Mr. Zack Crabtree
Big O Tires (Falcon)

Summary of Comments on Microsoft Word - Big O Tires -- report (addressed comments, 2018 March).docx

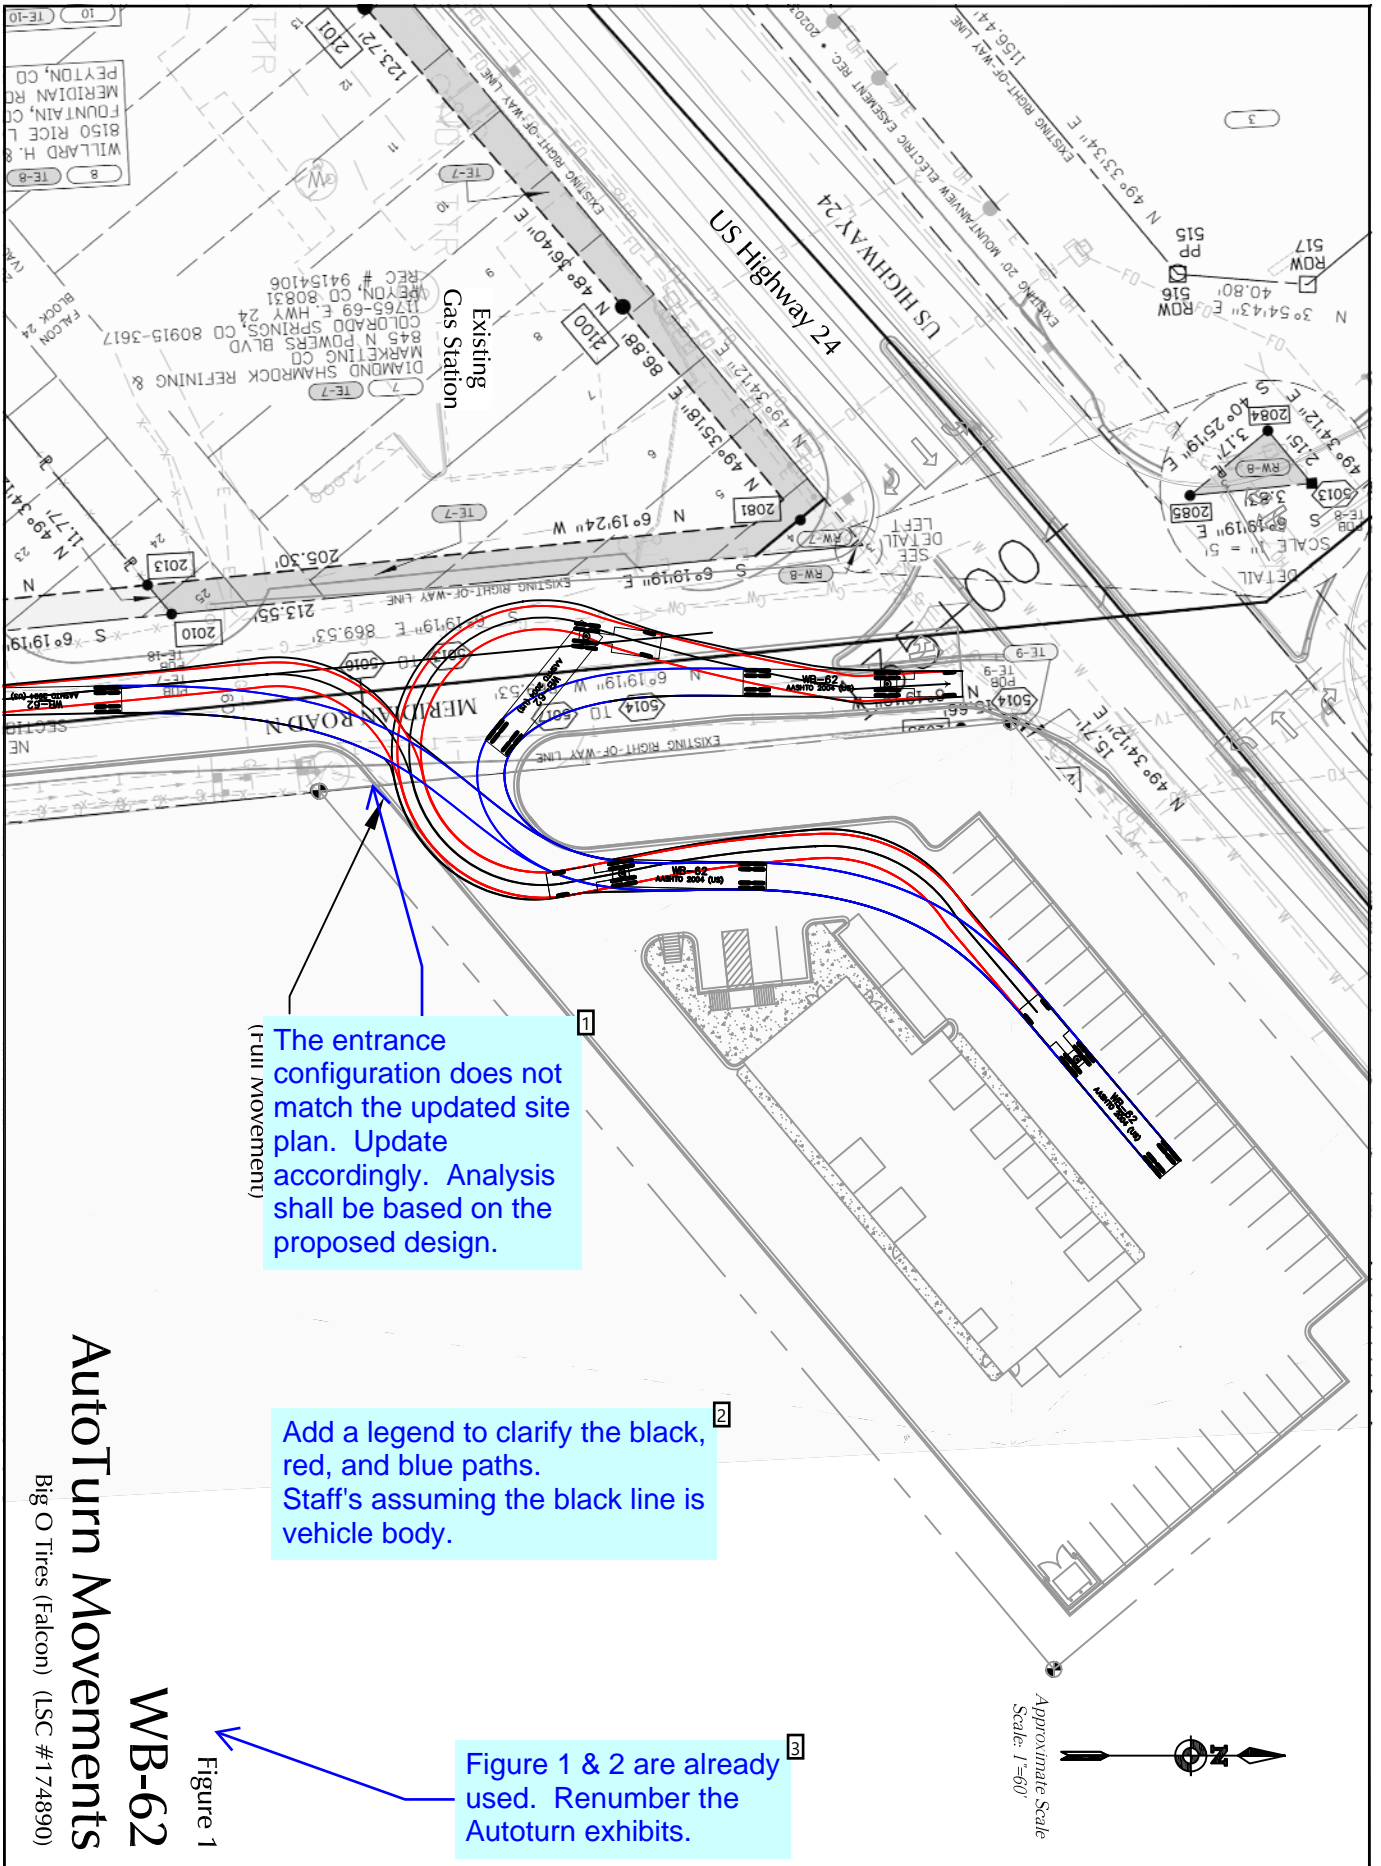
The entrance configuration does not match the updated site plan. Update accordingly. Analysis shall be based on the proposed design.

Add a legend to clarify the black, red, and blue paths. Staff's assuming the black line is vehicle body.

Figure 1 & 2 are already used. Renumber the Autoturn exhibits.
